Scoping Summary

Southern California Edison Company's Valley South Subtransmission Project

Application No. A.14-12-013

July 2015

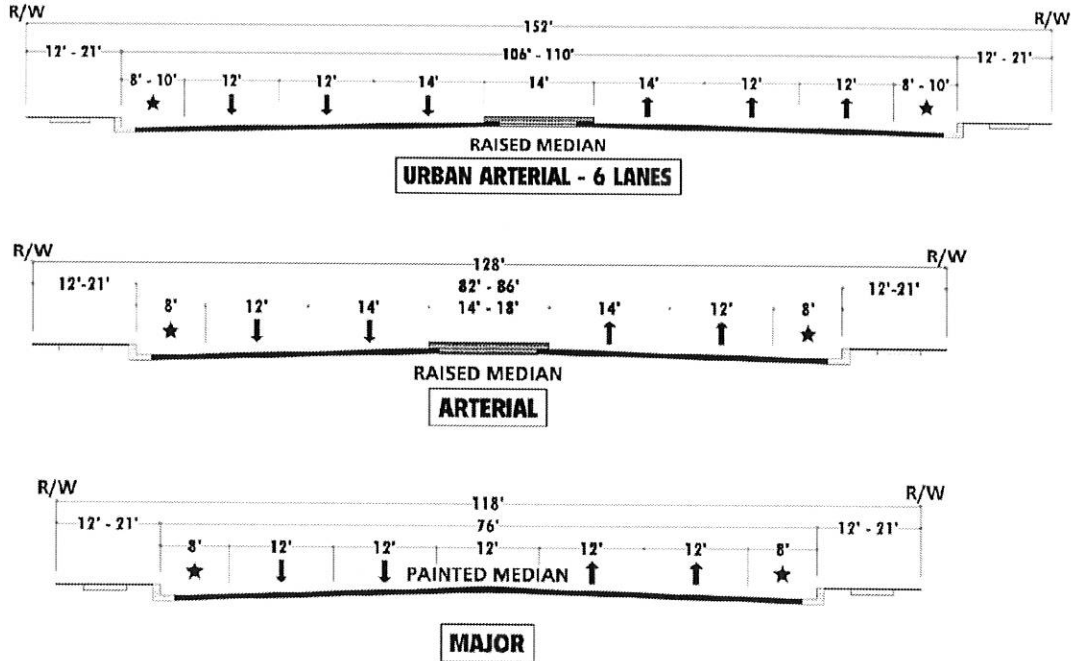
2. SCE should take into consideration the recently approved (December 2013) City of Menifee Circulation Element when designing the power pole alignment within the City limits. The poles should be placed at their ultimate location per the City's Circulation Element roadway cross-sections. The poles should be located either within the right-of-way's parkway or completely outside of the public rights-of-way within a private easement, but they should not be placed within the ultimate planned pavement, curb, gutter, trails, or sidewalks. For your reference, Briggs Road is designated as a Major (4 lanes, divided) roadway, McLaughlin Road as a Collector / Interconnected Local (2 lane) roadways, Scott Road as an Urban Arterial (6 lanes, divided) roadway, and Menifee Road as an Arterial (4 lanes, divided) . Refer to the corresponding cross-sections below.
